BUREAU OF LAND MANAGEMENT

We have received from your office a copy of Beaver Creek Coal Company's PAP Amendment, Second Mining East of Escarpment, Trail Mountain #9 Mine, ACT/-015/009-88A. We were to review and provide any comments or recommendations to your office concerning this proposal. Our response is to confirm telephone conversations between Stephen Falk in our Price office with Pamela Grubaugh-Littig of your staff.

Beaver Creek's proposal to proceed with limited second mining (partial pillar split) is to occur only between crosscut 63 and crosscut 38 of the South Mains. This area is entirely on State Section 36; the State of Utah controls the mineral and surface rights. This proposal occurs on non-Federal coal and surface and out of our jurisdiction to administer the Mineral Leasing Act. The BLM has been approached by Beaver Creek to evaluate the proposal and give opinion to the feasibility as an outside interest. We agreed to Beaver Creek's request. Please refer to our comments below.

# SOUTH MAIN PILLAR EXTRACTION SEQUENCE

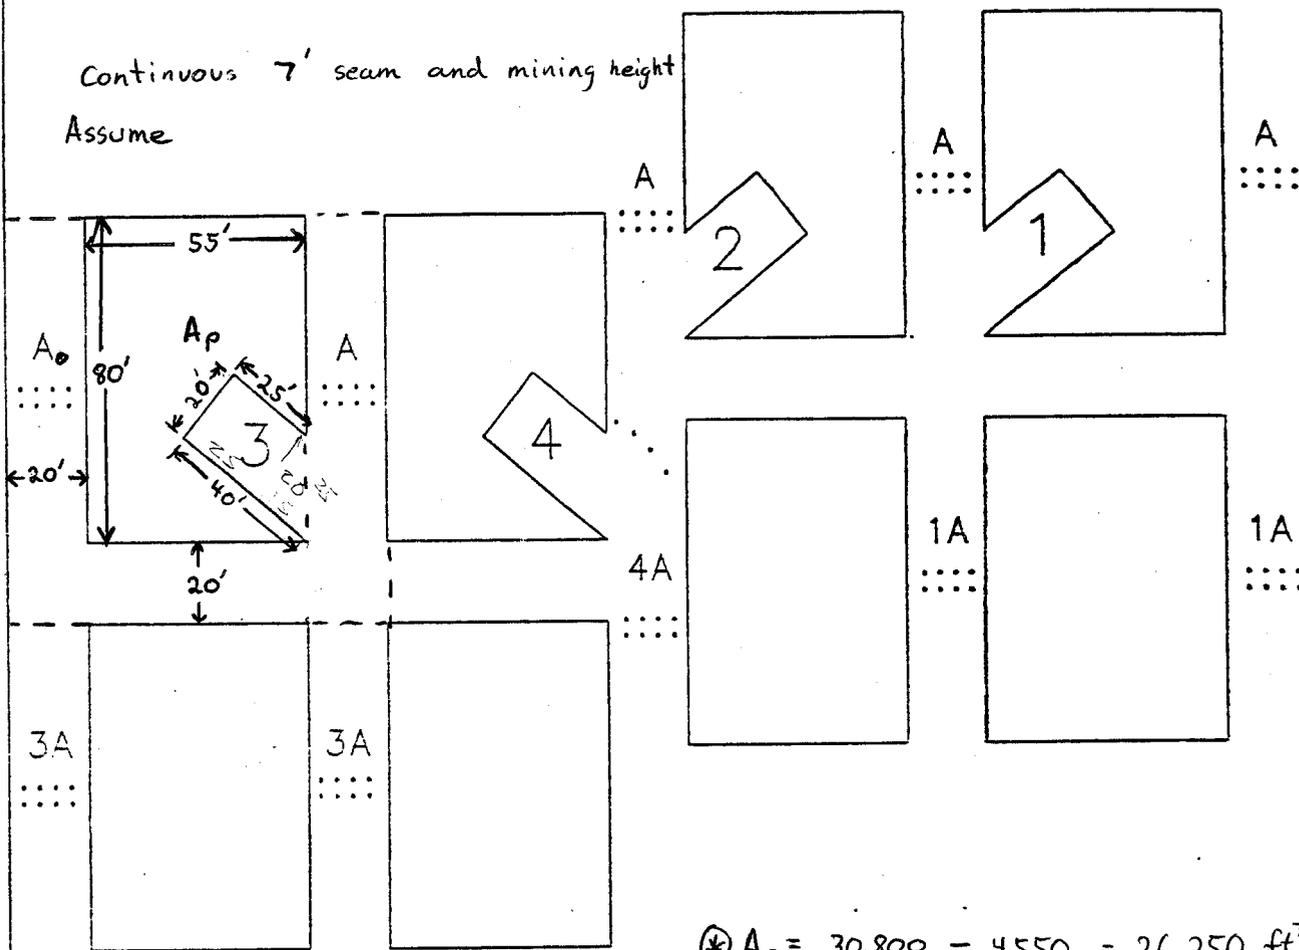
We have used another method from Obert and Duvall to substantiate Beaver Creek's conclusions. We looked at the exact partial pillar extraction sequence that Beaver Creek proposed to use in the South Mains. South Mains has 5 entries, with 4 pillars of 55x80-foot size. Beaver Creek plans to turn 30-foot cuts on angle into each pillar. With a standard 20-foot-wide mining cut, we figure that 4,550 ft.<sup>3</sup> of coal would be removed from each pillar based on an average 7-foot seam and mining height. The 55x80-foot pillar would have 26,250 ft.<sup>3</sup> left remaining after the 30-foot angled cut (see enclosed pillar extraction map). This scenario would give a 60 percent recovery in the mains with no accounting for panel barrier pillars. A design equation from Obert and Duvall is:

This assumption is accepted by industry and experts, though exact vertical stresses are very complex due to changes in geologic structures. For simplicity, the density of the overburden is 144 lbs./ft.<sup>3</sup>, which is a reasonable average of the various rock formations above. Hence, the vertical stress used in calculation is a direct relationship to the amount of overburden. The overburden in the area of proposed partial pillar extraction ranges from 1,300 feet to 1,000 feet. With the 60 percent recovery rate, the stress on the pillar will range from 3,250 psi to 2,500 psi.

Using the mean compressive strength and the range of overburden stresses, we calculate a factor of safety between 1.1 and 1.5.

This rock mechanics evaluation determines only failure of the pillar. It is assumed that if pillars fail, subsidence effects will manifest themselves to the surface in the form of cracks or ground lowering. This may or may not happen. However, we feel with the calculated stress scenario and the fact that large barrier pillars will remain in place on both sides of South Mains that the strata will hold and no subsidence will occur. One must also realize that a large pillar area in the 1st West panel was completely pulled before the permit stipulation for areas of no second mining was issued. This area was under the escarpment and no detectable subsidence failure has been observed. We therefore give our opinion that Beaver Creek's proposal will not cause failure of the escarpment.
